Memorandum

RE: Other Business for the January 26th, 2023, Planning Commission Meeting

Covered Bridge Inn (C/U 2177)

Bay Forest Club Phase 6 (Sprogell Infill Parcel) Residential Planned Community (RPC) HW
Preliminary Site Plan

SHEET TITLE
FINAL SITE PLAN

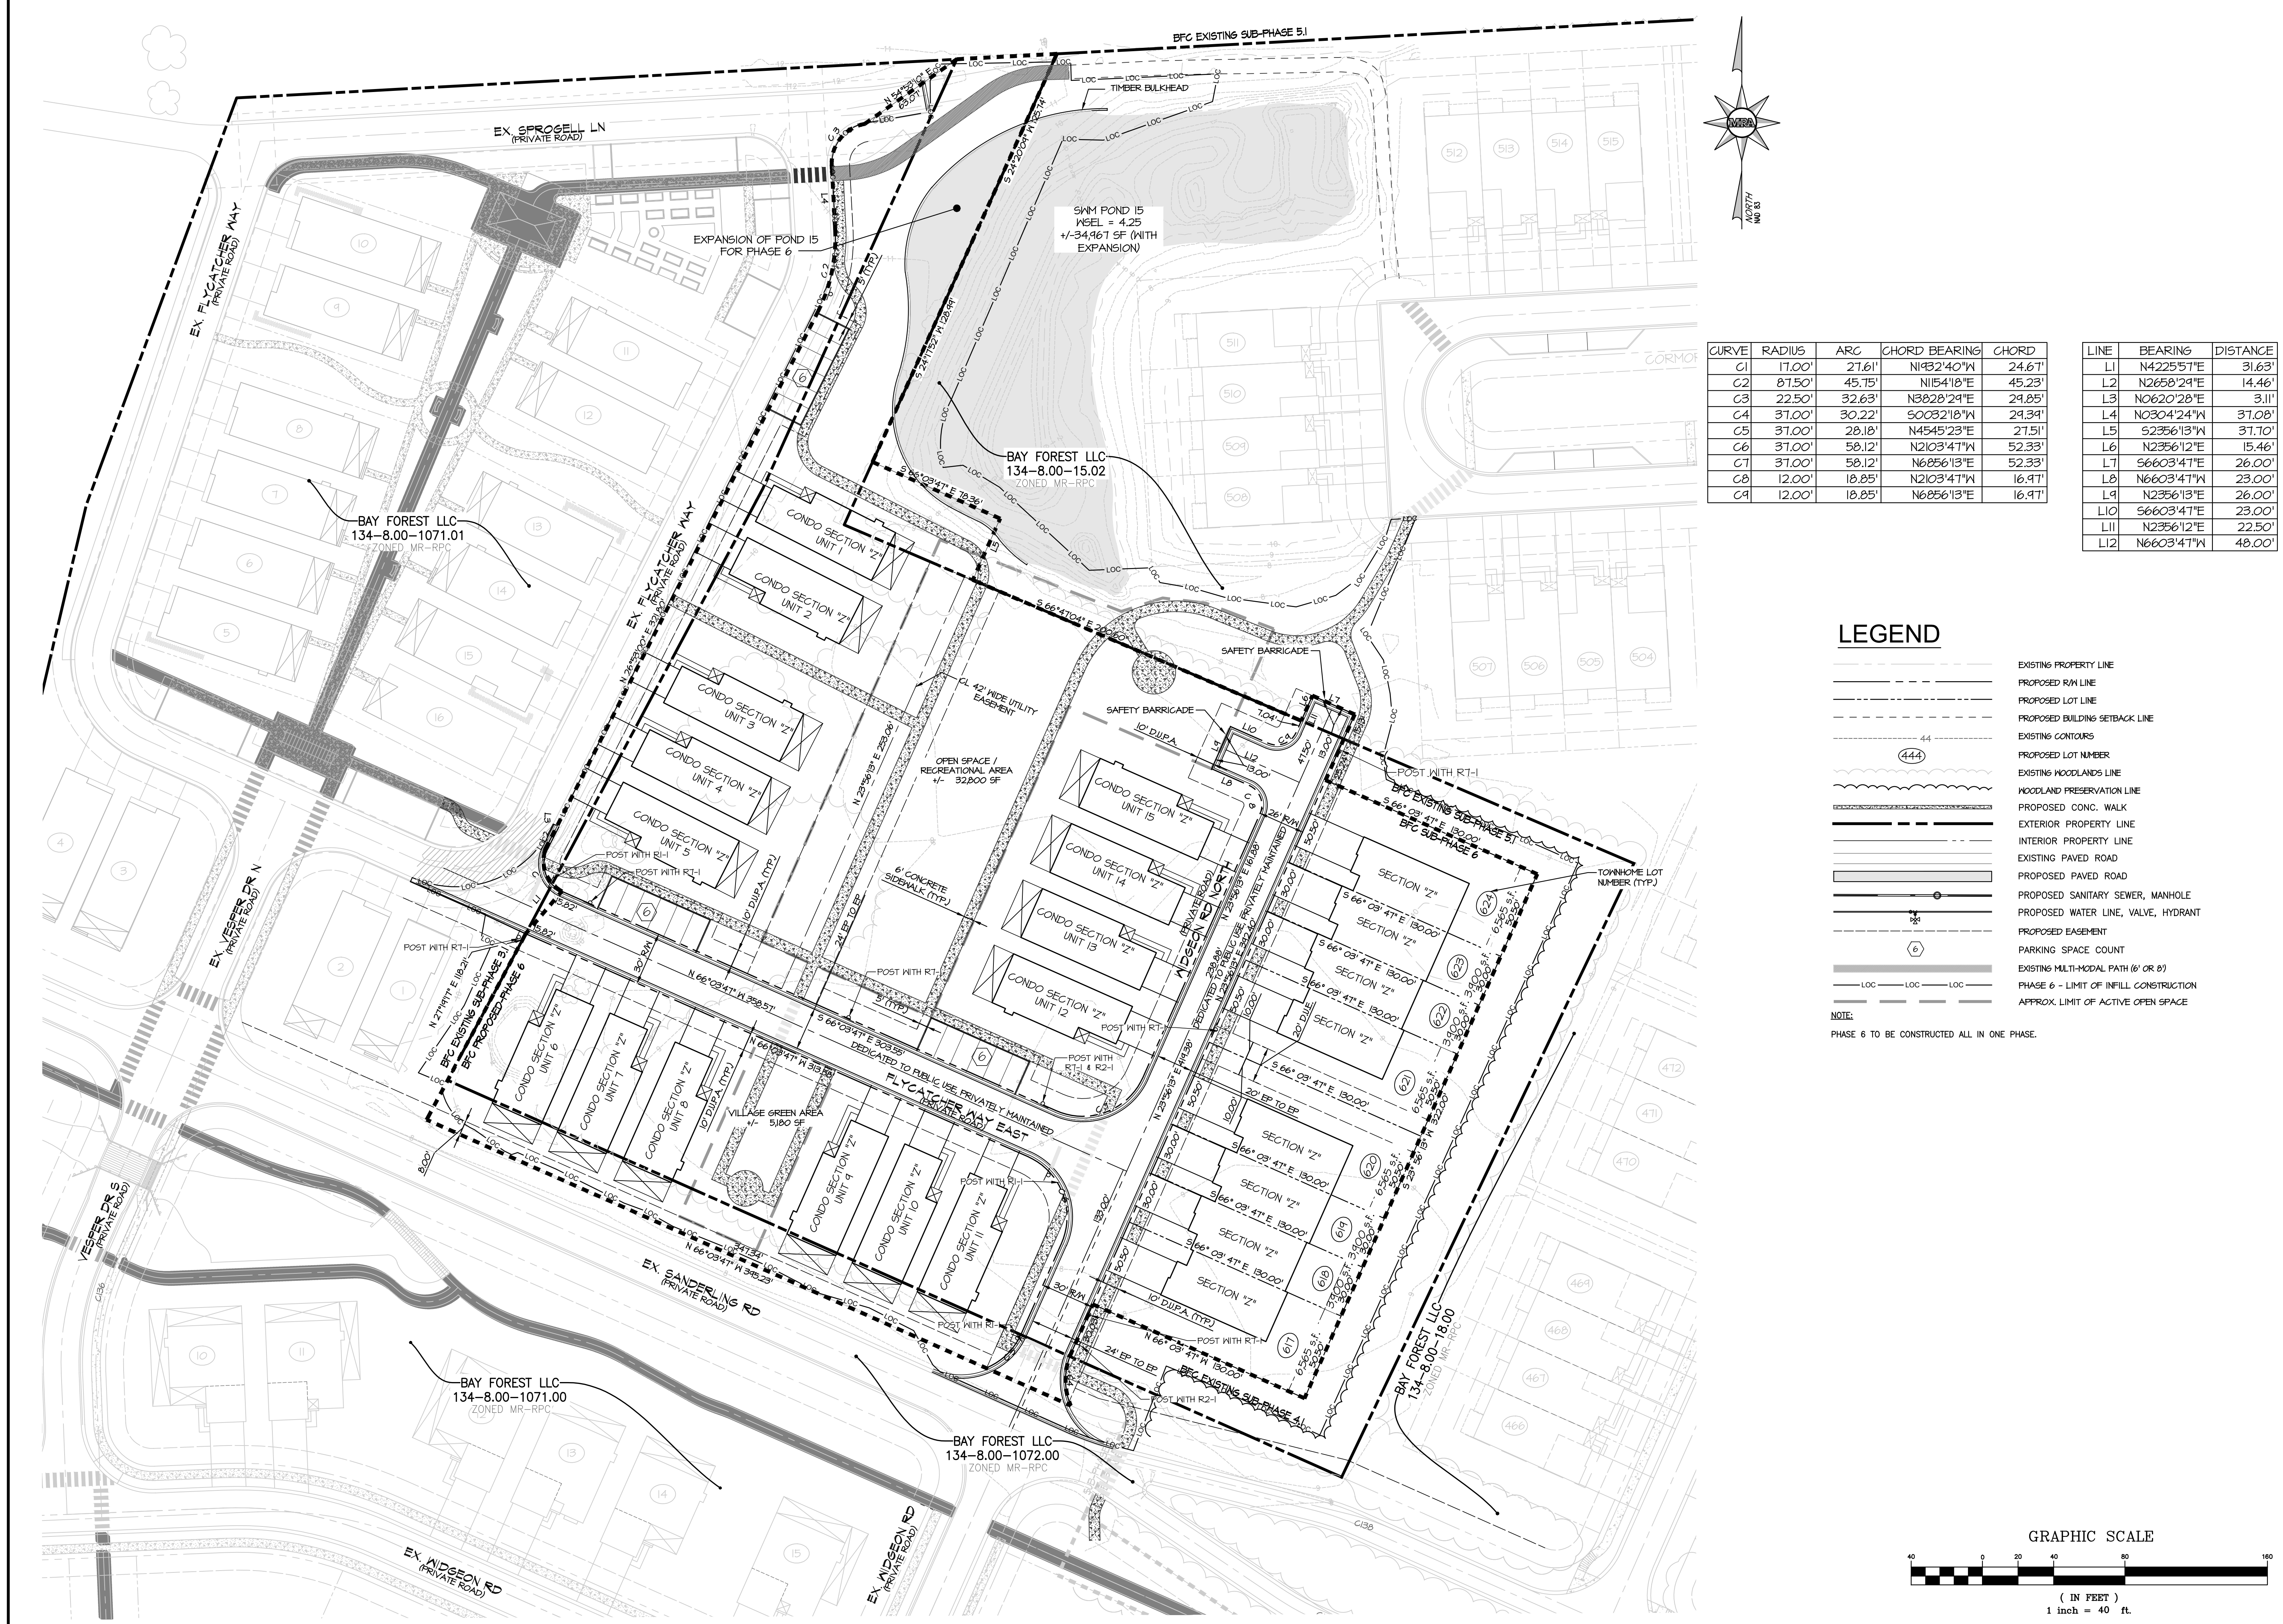
10. Please note that the Applications listed in the subheader of the Cover Sheet are Change of Zone Applications (Sheet 1).
11. Please clarify on the plans that this is Phase 6 of the Bay Forest Club RPC (Sheet 1).
